HaskoningDHV Vietnam Co. Ltd.
Water

To: Quang Nam PPMU; TEDIPORT Consultant
From: Huy Hoang
Date: 15/03/2021
Copy: World Bank; RVO
Our reference: VN2243-RHD-ZZ-XX-NT-Z-0001
Classification: Project related
Checked by: Karel Heijnert

Subject: Review of Pre-Feasibility Report (February 2021)

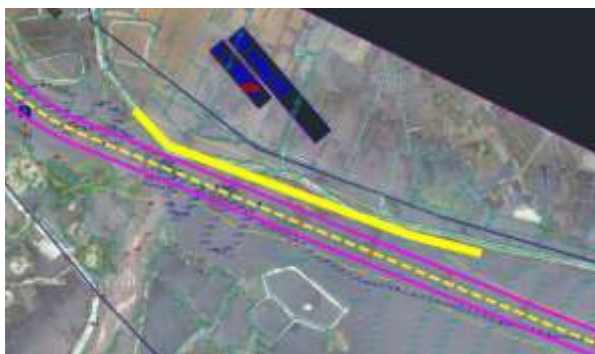
needs to also act as a retaining wall, hard structures seem more appropriate. Soft/green solutions need more space but are low tech and generally cheaper in case no land acquisition is required. They are also easier implemented (and maintain!) by local contractors. It is suggested to critically review these choices in the FS stage of the project. We realize that this may require a change of mindset and appreciation of stakeholders. Successful examples of implementation of nature based solutions can for example be found in Vietnam in the Mekong Delta.

K3

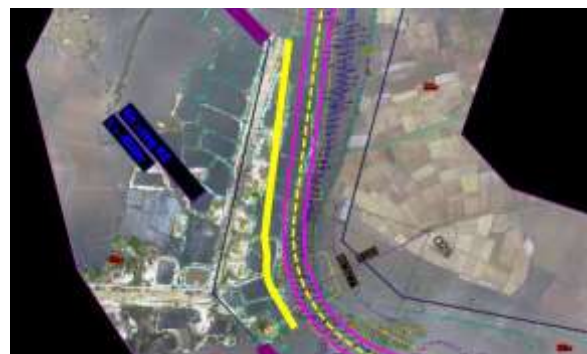
4. *Location of revetments in river.* The Pre-FS proposes to construct 'hard' revetments in the actual river at quite a number of examples. See situation sketches below for locations such as K3, K9, K10, and K12. We would suggest to reconsider this and only locate hard revetments, where needed, in the actual riverbank.

We propose to as much as possible comply to the principle of room for the river, and maintain and protect the current floodplain to remain flexible for future adaptation to trends like climate change. In case revetments need to be built in the floodplain of the river because of the presence of for example shrimp ponds, farms or houses that cannot be removed, we propose to choose for constructing green solutions. These green solutions are cheaper and more flexible to changing future conditions.

For communication purposes, it would be beneficial to clearly mark the boundaries of the original river system (including floodplains) in the plan designs like shown below.
